Access Compliance Report

Public Rights-of-Way

Intersection ID: 31884	Main Street: CENTERLINE_DR	Cross Street: LIFELINE_LN	Location: SW
ADA ID: 54A21E9EA9B9	Ramp Type: PerpDiag	Initial Pass/Fail: Fail	Overall Compliance: No
Severity Score: 22.5			
Codes/Mitigation Info/Possible Solution		Field Measurements/Component Compliance

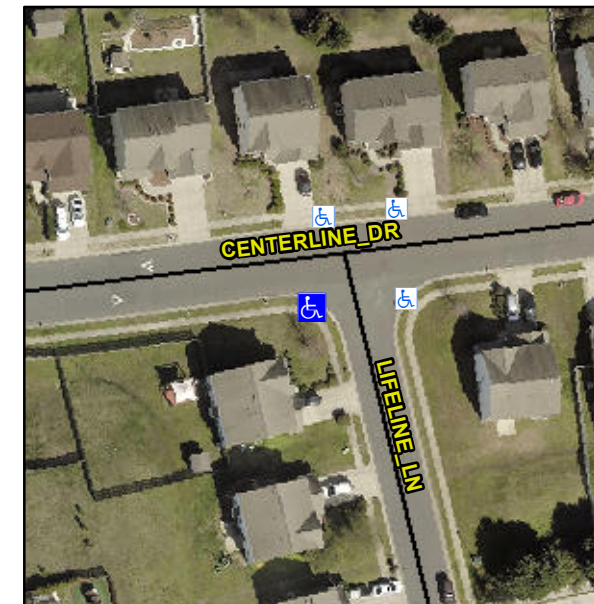
Not Found, R304.5.1, R304.2.2, R304.5.3

Compliance	Description	Data	Compliance	Description	Data
N/A	Ramp Length (in)	46.0	No	Ramp Slope (%)	8.6
No	Ramp Width (in)	47.5	No	Ramp XSlope (%)	2.8
N/A	Flare Type LT	N/A	N/A	Flare Type RT	N/A
N/A	Flare Slope LT (%)	N/A	N/A	Flare Slope RT (%)	N/A
N/A	Flare Traversable LT?	N/A	N/A	Flare Traversable RT?	N/A
N/A	Landing Length (in)	N/A	N/A	DWS Provided?	N/A
N/A	Landing Width (in)	N/A	N/A	DWS Contrast?	N/A
N/A	Landing Slope (%)	N/A	N/A	DWS Length (in)	N/A
N/A	Landing X Slope (%)	N/A	N/A	DWS Full Width?	N/A
N/A	Landing Curb? (Y/N)	N/A	N/A	DWS Offset (in)	N/A
N/A	Shared Landing?	N/A			
N/A	Gutter Ponding?	N/A	N/A	Gutter Slope (%)	N/A
N/A	Gutter Lip Ht (in)	N/A	N/A	Gutter X Slope (%)	N/A
N/A	Painted X Walk1?	No	N/A	Painted X Walk2?	No
	X Walk 1 Direction	To E		X Walk 2 Direction	To N
N/A	X Walk 1 Width (in)	N/A	N/A	X Walk 2 Width (in)	N/A
	X Walk 1 Slope (%)	3.1		X Walk 2 Slope (%)	2.5
	X Walk 1 X Slope (%)	1.2		X Walk 2 X Slope (%)	1.7

Remove & Replace Curb Ramp With Two New Directional Ramps or Equivalent.
